**BEFORE THE OFFICE OF ENERGY INFRASTRUCTURE SAFETY  
OF THE STATE OF CALIFORNIA**

**OPENING COMMENTS OF THE UTILITY REFORM NETWORK  
ON SAN DIEGO GAS AND ELECTRIC COMPANY'S  
2023-2025 WILDFIRE MITIGATION PLAN**

May 26, 2023

**Figure 1. SDG&E Undergrounding Decision Tree**

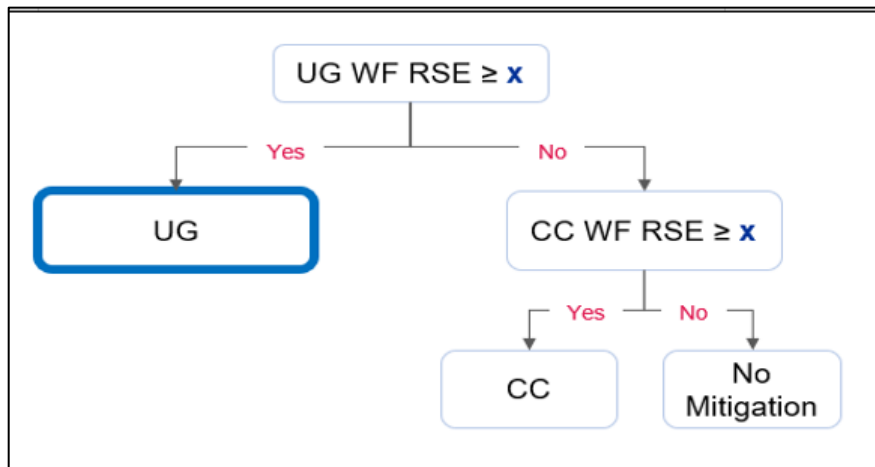
In SDG&E's GRC, TURN obtained through discovery the following decision tree that SDG&E uses when choosing whether to deploy covered conductor or undergrounding.<sup>30</sup>

Under this decision tree, SDG&E does not ask which measure would be the most cost-effective. Instead, it asks *first* whether undergrounding would meet a pre-determined – but unspecified – threshold. If not, and only in that case, does SDG&E consider covered conductor, again comparing it to an unspecified threshold.

Thus, SDG&E clearly is not making its selection based on the most cost-effective alternative (even under its biased risk modeling). SDG&E's process puts undergrounding in the pole position and only gives covered conductor an opportunity for consideration if the undergrounding RSE falls below a certain value, for which we have seen no justification regarding how and why this value was selected.

Energy Safety should also be troubled by SDG&E's failure to disclose this decision tree in its WMP. It should have been presented in response to Area of Continuing Improvement (ACI) 22-14, in which Energy Safety stated: "SDG&E's description of how it selects mitigation

The decision tree shown above is obviously central to how SDG&E selects system hardening initiatives and should have been disclosed. Energy Safety should require SDG&E to explain why it withheld this important information, which reveals the evident bias in how SDG&E chooses between undergrounding and system hardening.

**Figure 2.**  
**RSE of Undergrounding vs. Covered Conductor, WiNGS Model Analysis,**  
**Sorted by Risk per Mile**

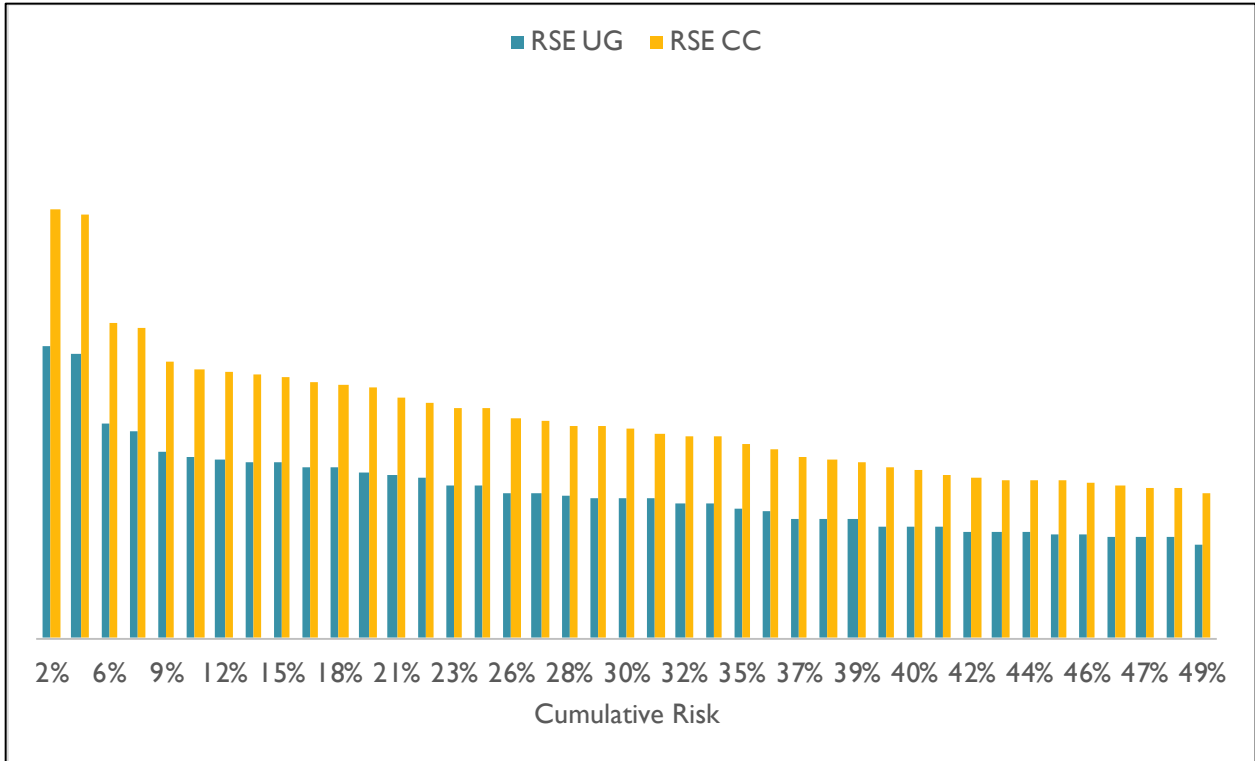
If SDG&E chose between undergrounding and covered conductor based on which mitigation is more cost-effective in a given location, TURN’s GRC analysis shows that covered conductor would likely be chosen in most locations. Even using SDG&E’s biased risk modeling as discussed in Section III, including an excessive cost for covered conductor, TURN found that covered conductor has a higher RSE at all risk levels for the top 50 percent of wildfire risk where SDG&E has planned an undergrounding project, as shown in the following figure:<sup>33</sup>

TURN found that SDG&E’s WiNGS model results show that, on average, covered conductor is about 50 percent more cost-effective than undergrounding.<sup>34</sup>

SDG&E is systematically rejecting the most cost-effective system hardening mitigation, covered conductor, in favor a much more expensive and risky option that takes longer to deploy than overhead hardening. More risk reduction can likely be obtained more quickly through deployment of covered conductor, as we show in our PG&E WMP comments. To avoid a poor

use of limited ratepayer resources, SDG&E should be directed to revise its system hardening selection process and to correct its risk modeling that is biased in favor of undergrounding.
